AusNet Services Transmission Revenue Proposal 2027-32

# REVIEW OF PROPOSED MAJOR STATIONS REPEX PROJECTS

Report prepared for:  
**AUSTRALIAN ENERGY  
REGULATOR**  
March 2026

Figure 4.2: Failure rate sensitivity of preferred Option 1 – MLTS CB replacement

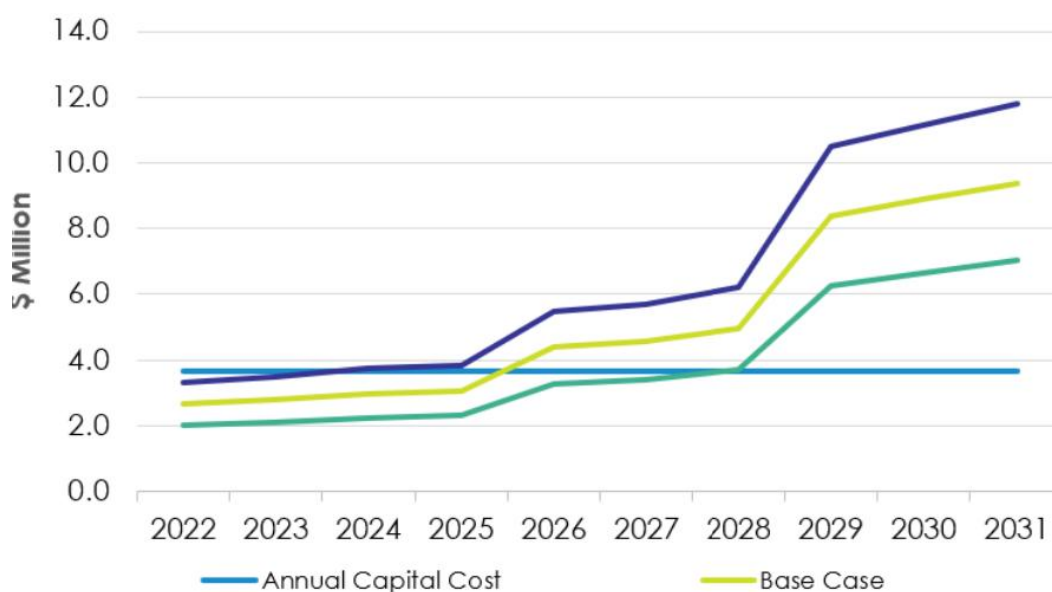
205. The base case economic timing is 2026, however the revised and current scheduled project completion date is 2028.<sup>67</sup> We see no grounds for prudently deferring the project into the subsequent RCP.
206. The economic timing is most sensitive to changes in the plant failure rate. Using the sensitivity analysis undertaken by AusNet as shown in Figure 4.2, the annual benefits can be seen to increase in 2026 and 2029.<sup>68</sup> Reducing the PoF of the switchgear by 25% defers the economic timing to 2028 or 2029, which is well within the next RCP and, in any case, aligns with AusNet's scheduled project timing.

Figure 4.4: Summary of SYTS project cost movement

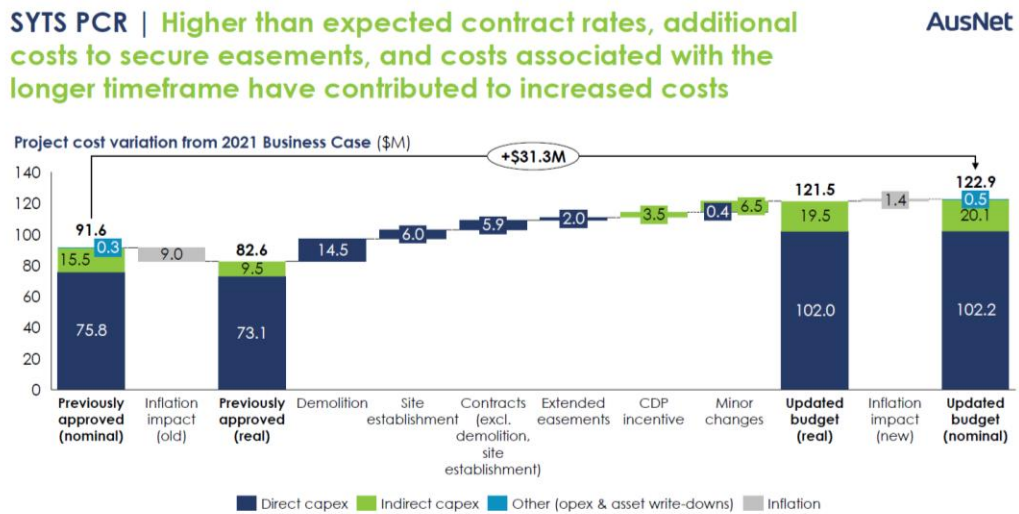
273. AusNet states that it has conducted market testing to validate delivery partner prices, with the changes requiring a 19-month delay (from September 2025 to April 2027) and \$31.3 million (nominal) increase to the budget comprising a range of cost increases / revisions, and the scope has been expanded to include the procurement of extended easements at 1 Holden Road for the SYTS rebuild. We show the build-up of costs in Figure 4.4.

274. The cost movements illustrated in Figure 4.4 are similar in magnitude to those indicated in Table 4.10.
275. We understand that the SYTS 500kV GIS Replacement Board paper provided approval of the PCR and therefore contains similar material. In addition to the AIS date extended to April 2027, the PCR included an extension to the project completion date, updated from 30 December 2025 to March 2028:<sup>94</sup>

Figure 4.5: Sensitivity analysis for KTS transformer replacement – demand forecast<sup>108</sup>

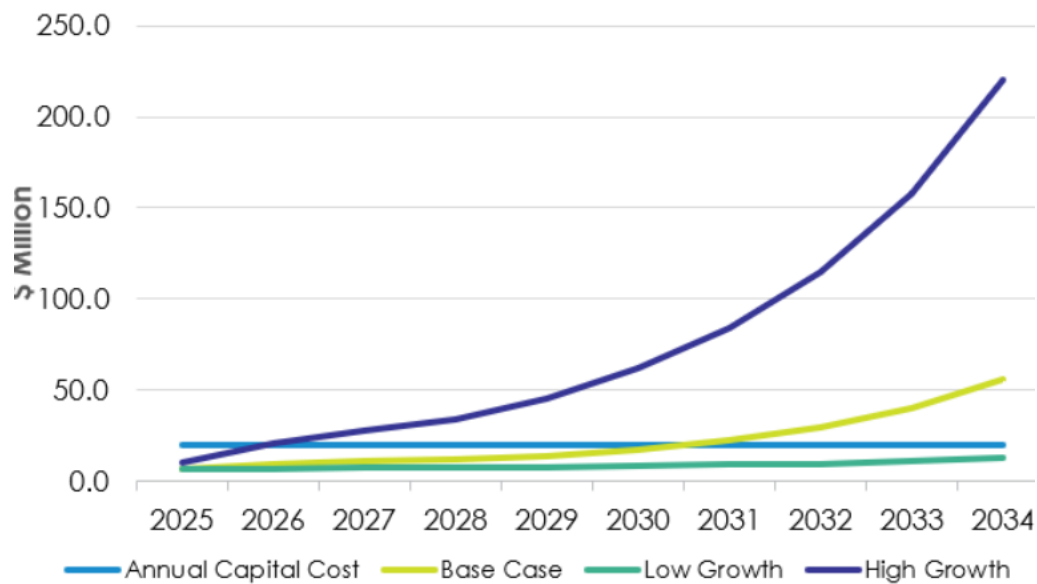
294. AusNet’s economic model results in economic timing of 2030, noting that AusNet plans to complete the work in FY32 due to delivery constraints.
295. Our review of AusNet’s sensitivity analysis indicated that the project was sensitive to changes in the demand forecast as shown in Figure 4.5. Based on its original modelling, a 15% lower demand forecast than it had assumed in its base case forecast, resulted in deferral of the economic timing well beyond the end of the next RCP. An alternative Low Growth scenario of -10% of the base case results in the economic timing of 2034, whereas a -5% Low Growth assumption defers the economic timing to 2032 (i.e. within the next RCP).

Figure 4.7: Benefit stack for SMTS 500kV GIS switchgear and F2 transformer replacement

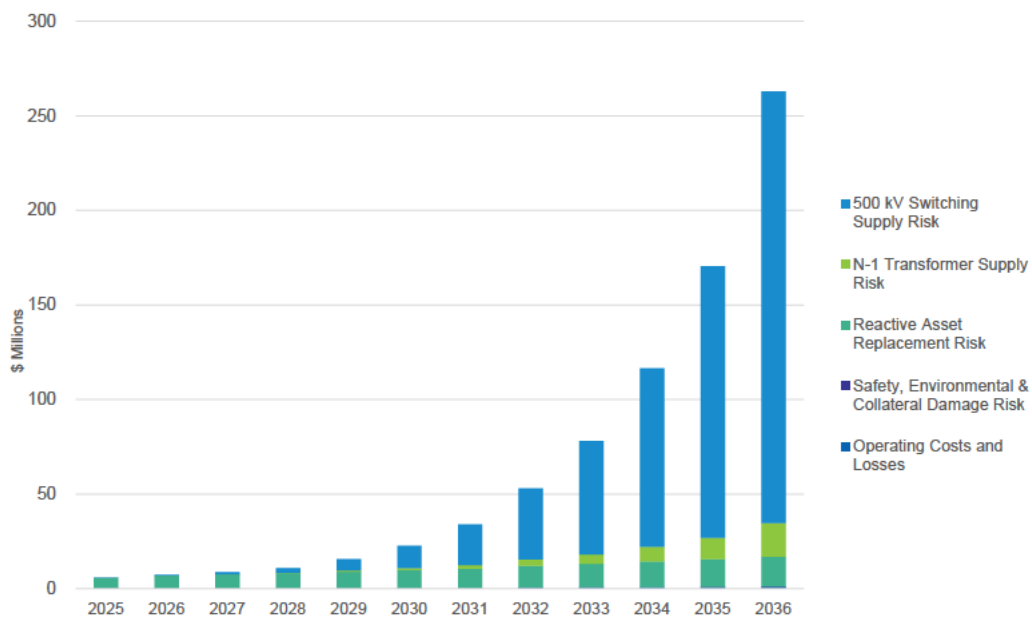
325. On review of the economic model, the benefits (and therefore economic timing) for replacement of the 500kV GIS switchgear and F2 transformer is driven by 500kV switchgear supply risk as shown in Figure 4.7

Figure 4.9: Sensitivity analysis of ROTS GIL replacement - failure rate

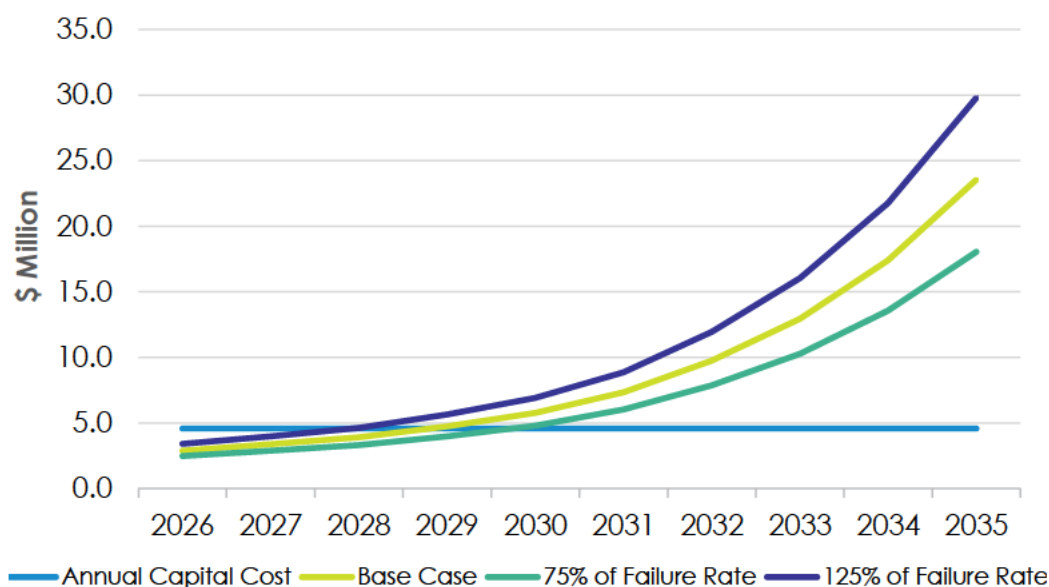
343. The primary driver of risk-cost is the reactive replacement of these assets given the condition of the existing GIL. We therefore considered how sensitive the economic analysis was to changes in the PoF that AusNet has assumed.

344. Further to AusNet’s sensitivity analysis which is shown in Figure 4.9, we changed the value to 25% for the low case (representing a 75% reduction in the assumed PoF) and the project remained economic to proceed within the next RCP.

Figure 4.10: Sensitivity analysis of TTS CB replacement project – failure rate, showing base case and low case annualised capital costs

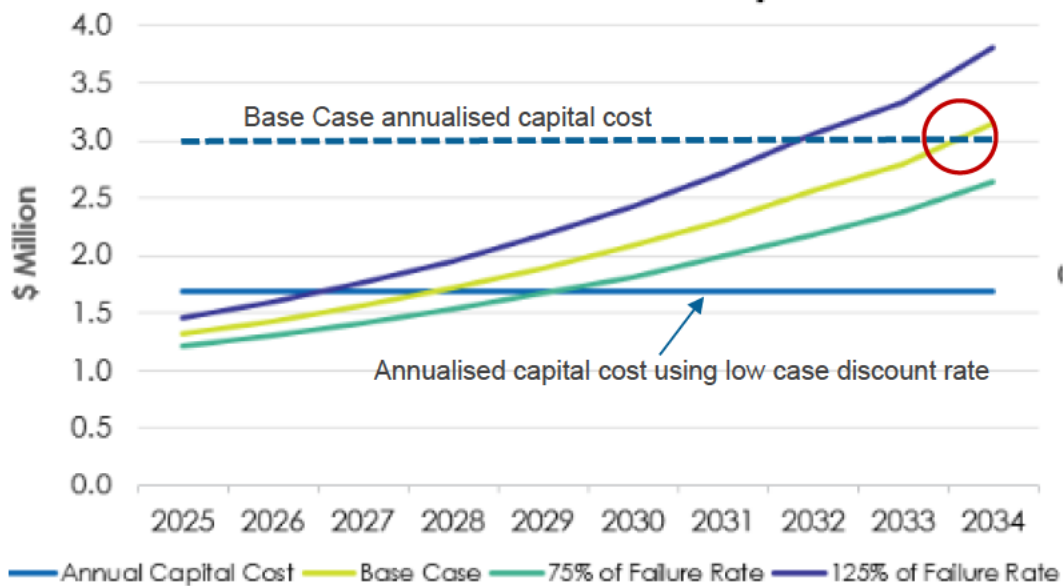
373. Figure 4.10 also shows the sensitivity of the economic timing to the asset failure rate, which illustrates that the economic timing would be even later (2035 or 2036) with a 25% reduction in the failure rate and using the base case annualised capital cost. The relatively high assumed aggregate PoFs for the 66kV switchgear (in particular) as discussed above indicates to us that the assumed PoF may overstate the benefits, and adjustment to those benefits will result in deferral of the project economic timing.

Figure 4.12: Sensitivity analysis for NSPD GIS 220kV replacement - demand growth<sup>156</sup>

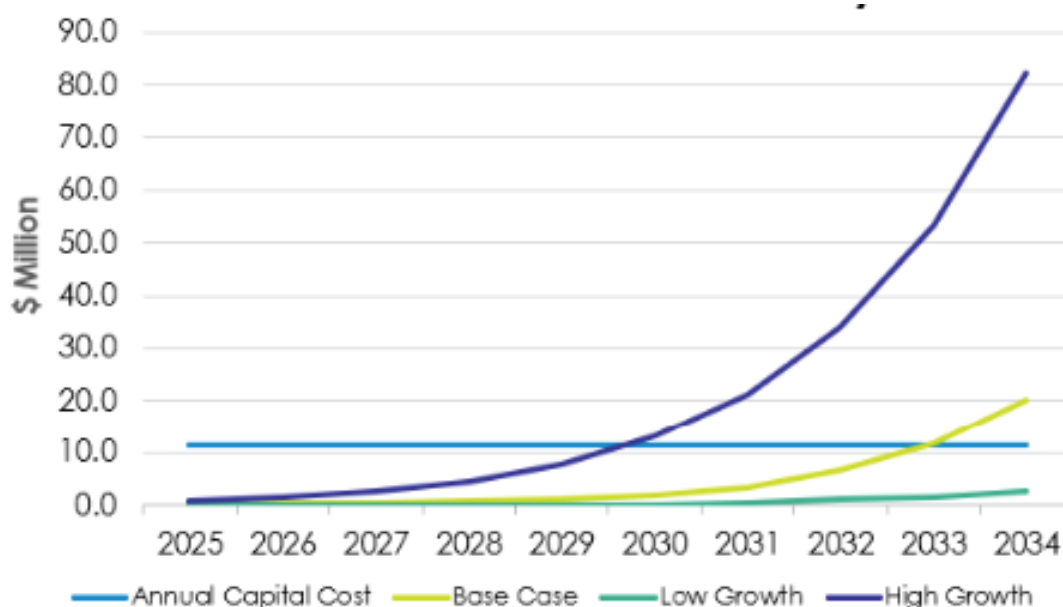
425. In its PPR, AusNet refers to the economic timing being 2033:<sup>153</sup>
- 'Figure 5 shows that the optimal timing of the preferred option (Option 1) is starting from 2033 with the project completion by the end of 2032 and that investment is needed within the 2027 to 2032 regulatory control period.'*

427. The economic timing is most sensitive to demand growth assumptions, as shown in Figure 4.12, with a 15% reduction in peak demand deferring the economic timing well beyond 2034. Conversely, a 15% increase in demand would bring forward the economic timing to 2030.

Figure 4.13: Sensitivity analysis of MLTS shunt reactor replacement – Asset failure

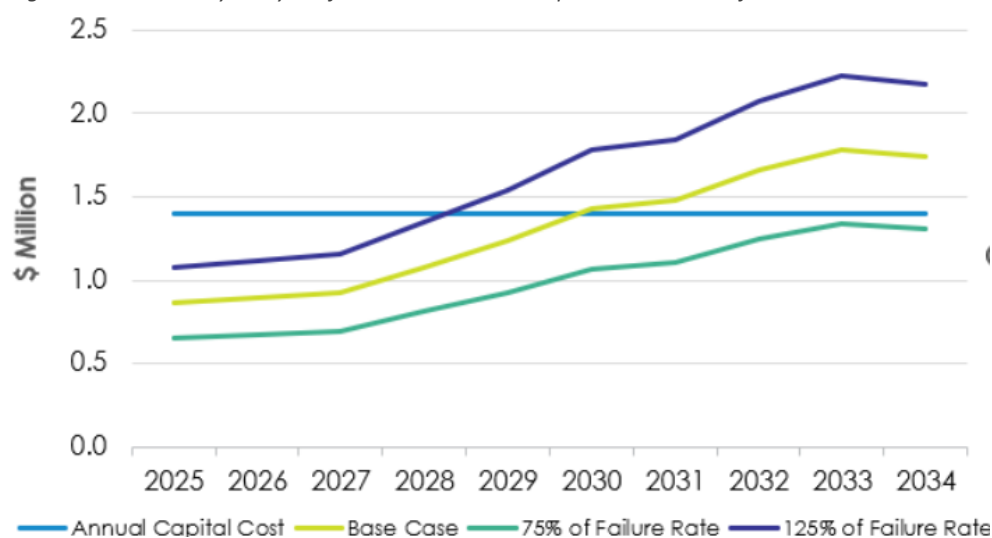
460. The base case assumptions applied to Option 1 lead to an economic timing of 2030, with AusNet advising it is planning to finish the replacement in 2031 due to deliverability constraints.

461. However as shown in Figure 4.13, the economic timing is deferred beyond 2034 for the low case PoF (-25%) with a 45-year study period. Given the 10-year horizon, changes to the modelling period to account for uncertainty in market benefits does not impact the economic timing, that is, when the benefits exceed the annuitised cost.

Figure 4.14: TTS B4 transformer replacement – economic timing demand growth sensitivity

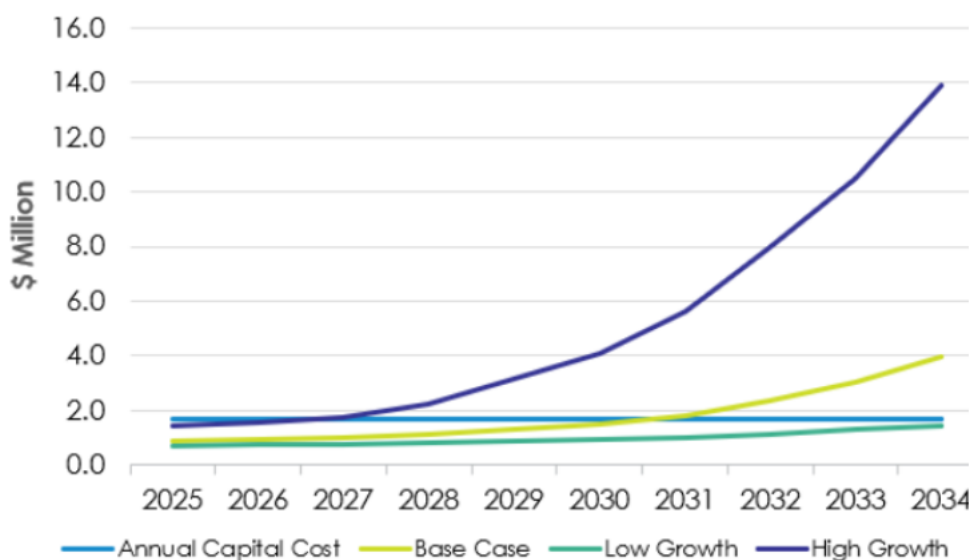
- 505. As shown in Figure 4.14, the economic timing derived from AusNet’s economic model is 2031. The figure also shows that the economic timing of the project is most sensitive to demand growth:

- If demand growth is 15% higher than AusNet’s forecast, the economic timing for the transformer replacement project is brought forward to 2027
- Conversely, if demand growth is slower than forecast, the economic timing is 2035, a four-year delay, all other things being equal.

Figure 4.15: Comparison of proposed and EMCa adjusted major stations repex (central estimate) for next RCP (\$m, real March 2027)

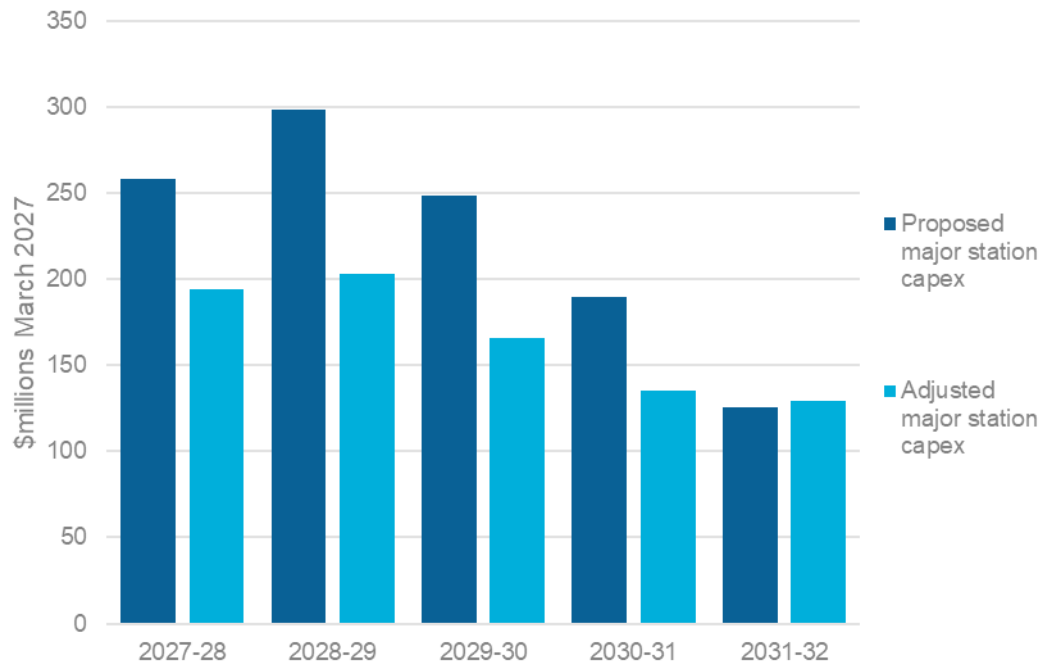
522. We propose adjustments for the issues that we have identified, and which lead us to a central estimate of the required capex for major stations repex as approximately 26% lower than AusNet has proposed as shown in Table 4.30 and Figure 4.15.
